ADDENDUM NO. 1

**EDGEMONT SCHOOL DISTRICT
GREENVILLE & SEELY PLACE SCHOOLS
HVAC UPGRADES AND CAFETERIA RENOVATIONS**

DATE: January 24, 2023

This Addendum consists of three (3) Pages, Sketch SK-A1.0, revised drawings GVES M200, GVES E101, SPES MD100, SPES M100, SPES M101, SPES M102, SPES M103, SPES M104, SPES M200, SPES M203, SPES M300, SPES M400, SPES ER100, SPES ER104, SPES E100, SPES E103, and SPES E104.

DRAWING SPES P100 – BASEMENT PLUMBING PLANS

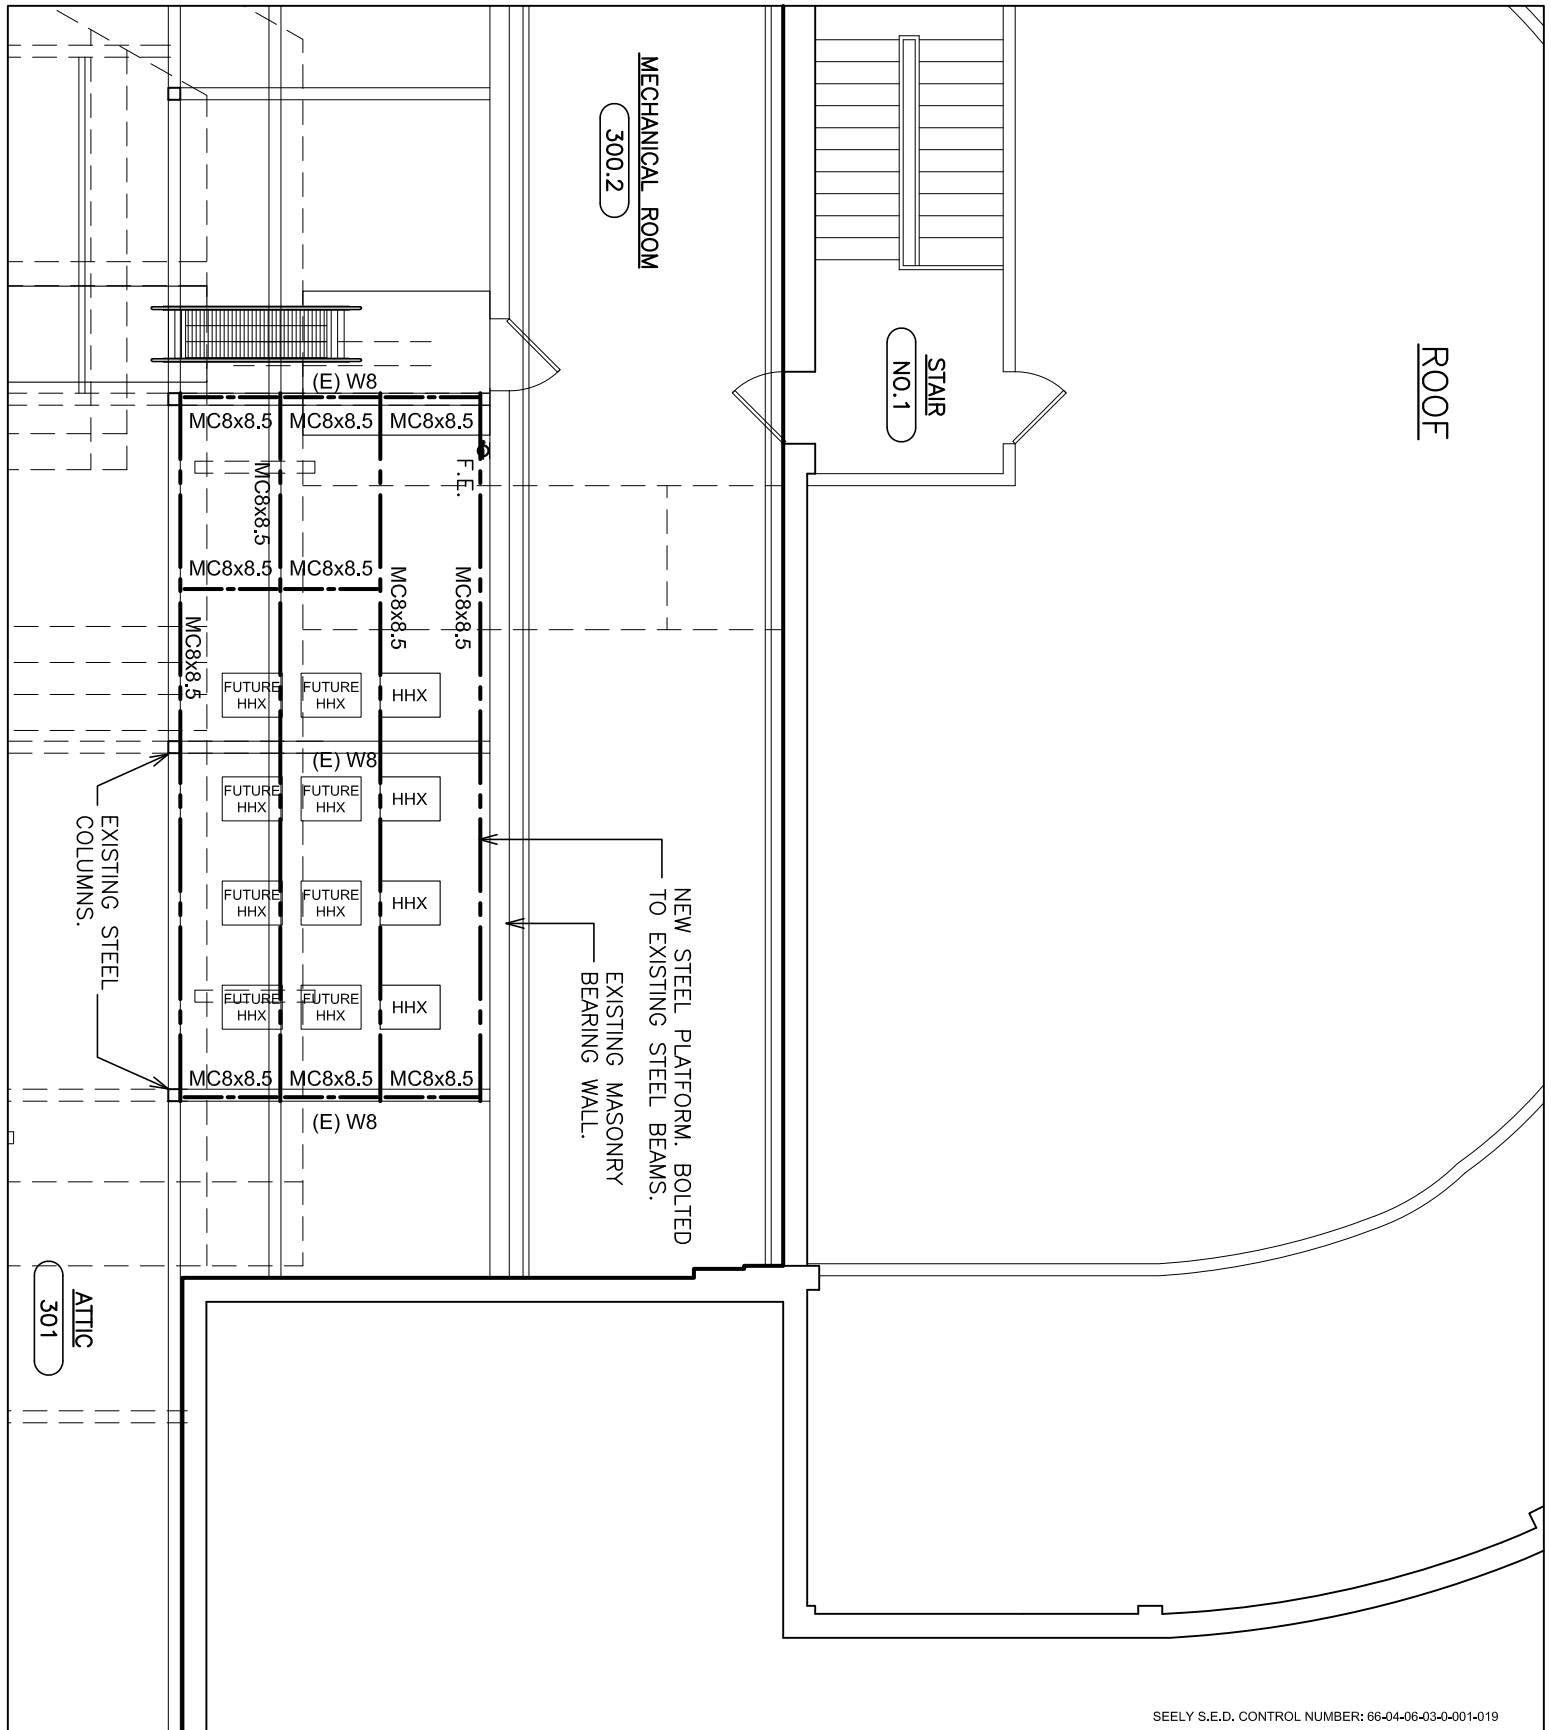
Detail 2, **REVISE** fixture in Janitor’s Closet from FS-1 to MSB-1.

FILE NO. 21434.01
DRAWING NO. SK-A1.0

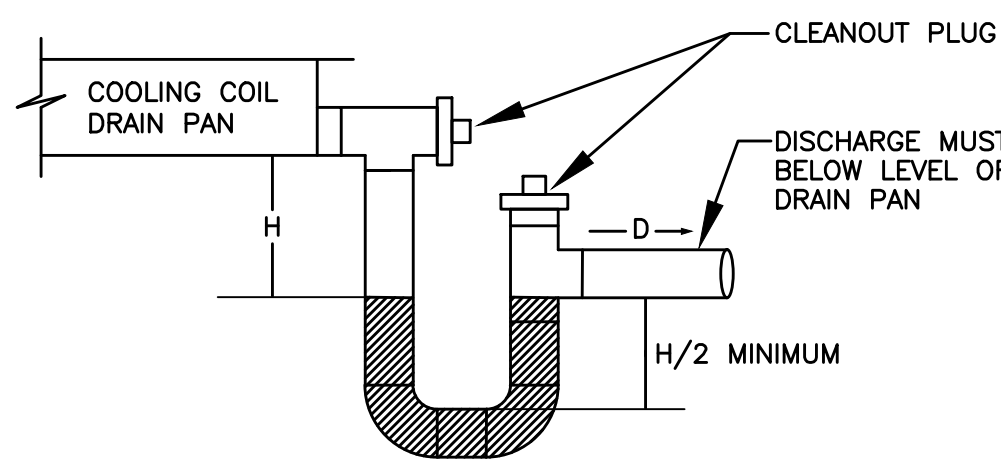
DRAWING SPES A103 – ROOF AND ATTIC PLAN

ADD partial framing plan as show on Sketch SK-A1.0 attached to this addendum.

ROOFTOP UNIT INSTALLATION DETAIL
NO SCALE

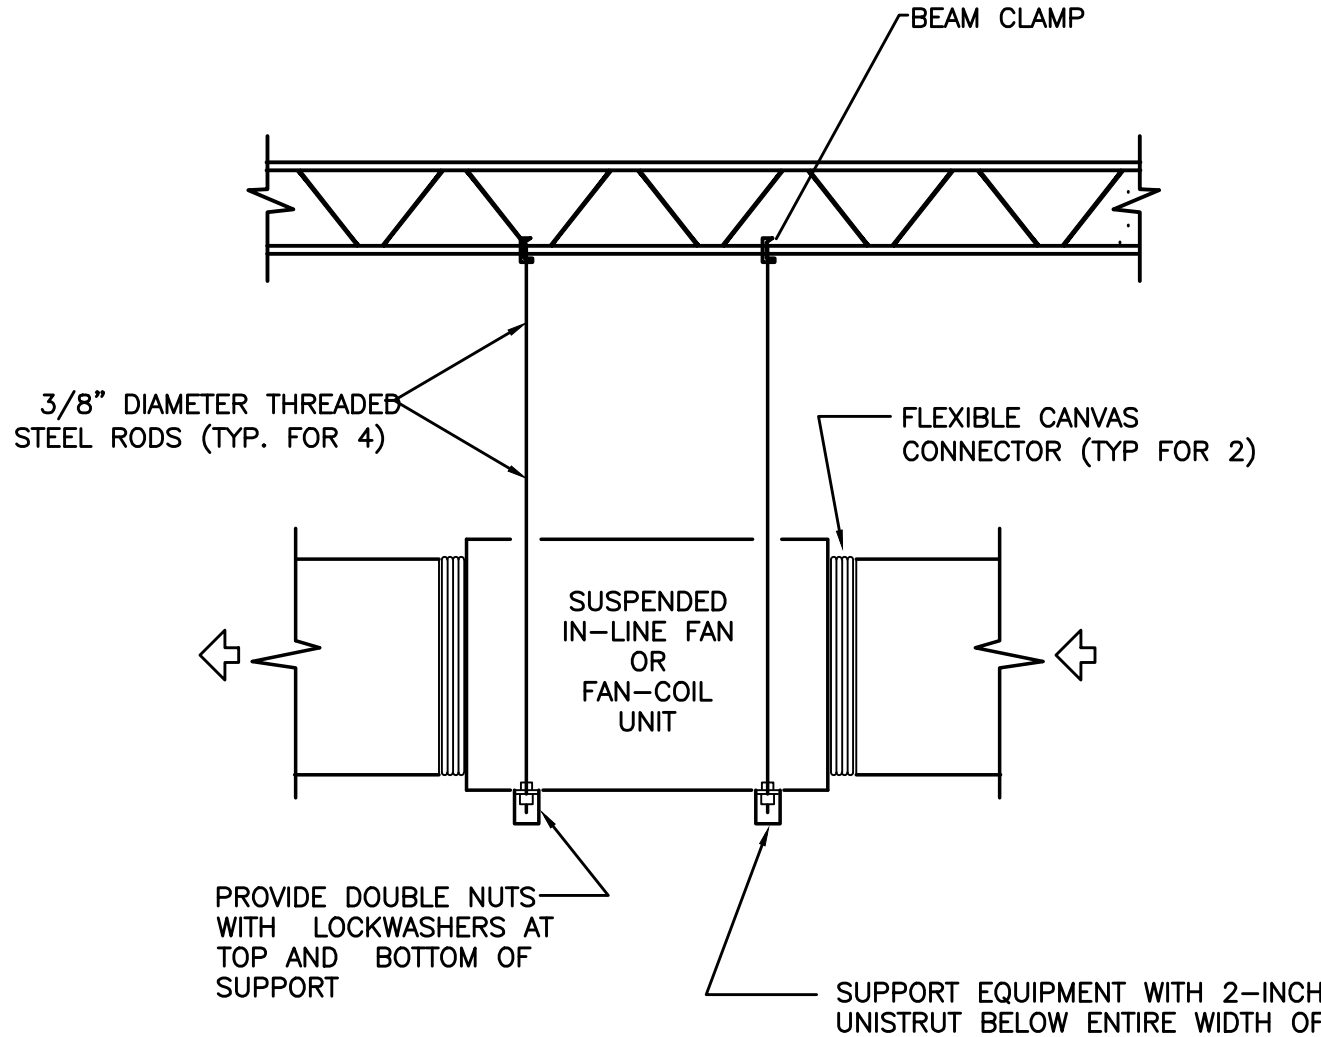
DRAWING GVES M200 – MECHANICAL DRAWINGS

Rooftop Unit Installation Detail, **REVISE** ductwork note as shown on drawing attached to this addendum.

NOTE:
REFER TO A-152 FOR DUCT SUPPORT DETAILS

1-24-2023	ADDENDUM #1
1-06-2023	BID
DATE	ISSUED TO
SHEET SIZE: 30"x42"	DRAWING NO. SPES MD100
SCALE: AS NOTED	FILE NO. 21434.01
DRAWN BY LFG

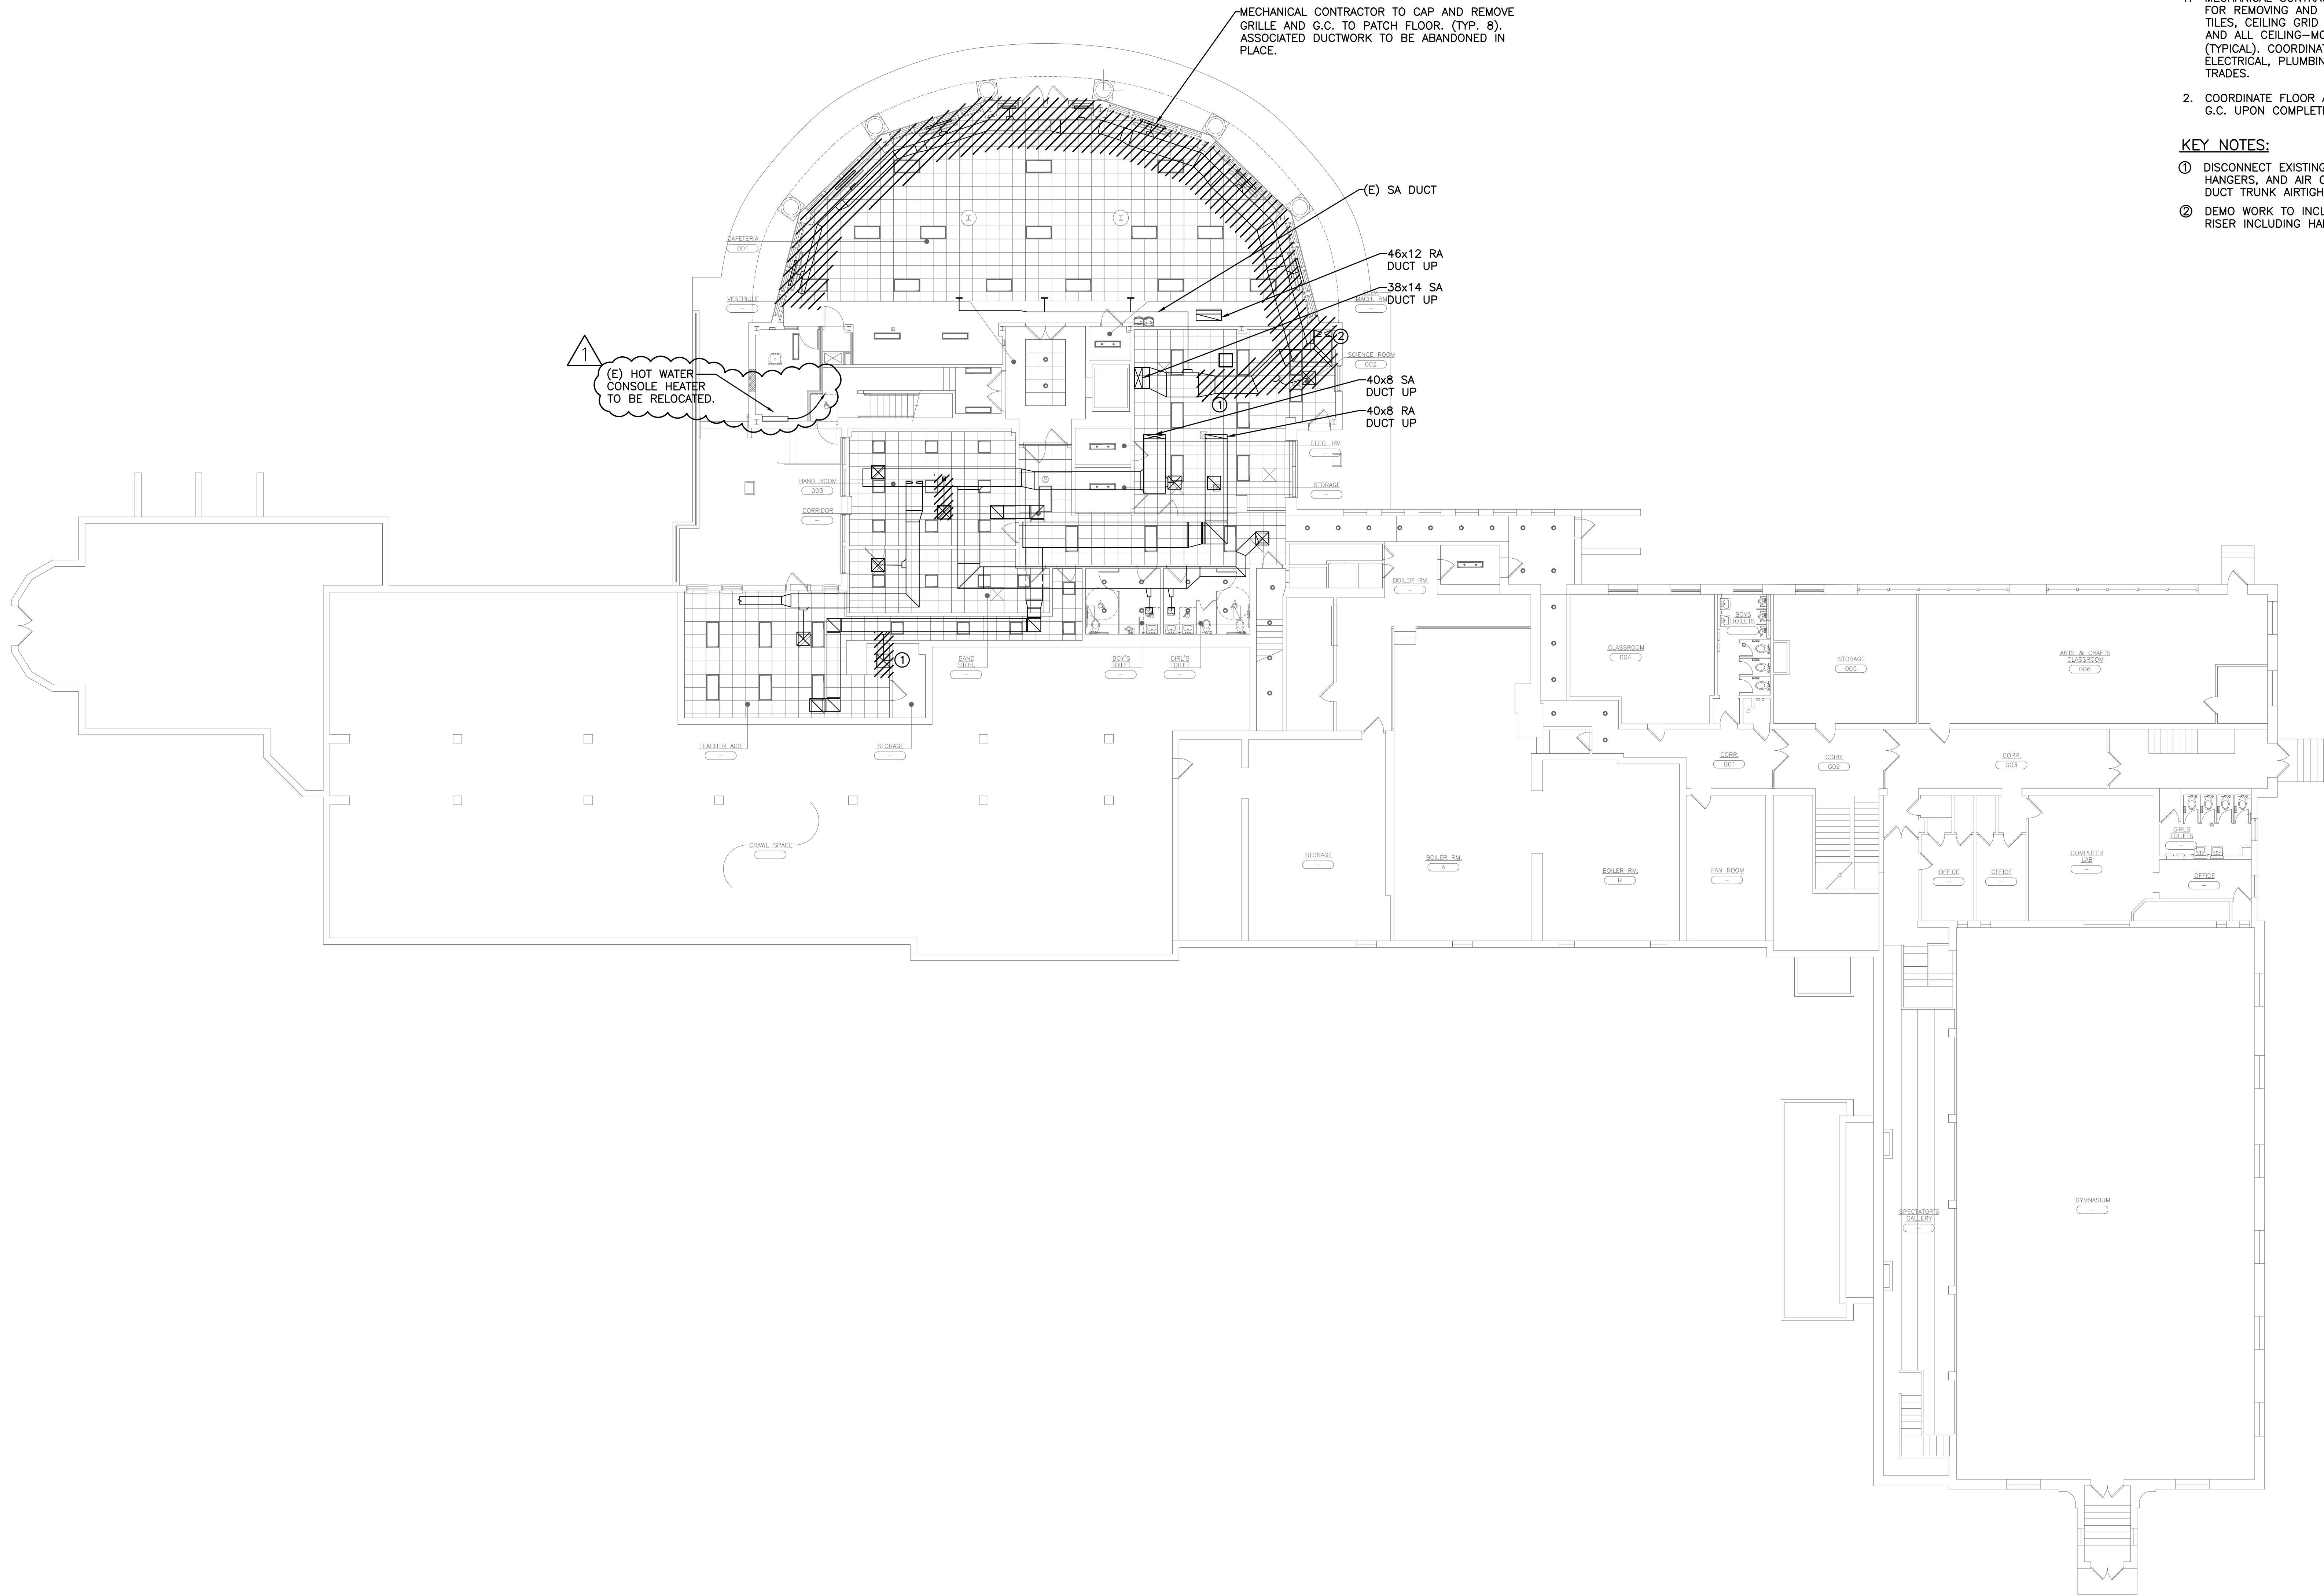
DRAWING SPES MD100 – MECHANICAL DEMO PLAN LOWER LEVEL

Detail 1, **ADD** removal note as shown on drawing attached to this addendum.

- DISCONNECT EXISTING BRANCH DUCT, HANGERS, AND AIR OUTLET. CAP AND SEAL DUCT TRUNK AIRTIGHT.
- DEMO WORK TO INCLUDE EXISTING DUCTWORK RISER INCLUDING HANGERS.
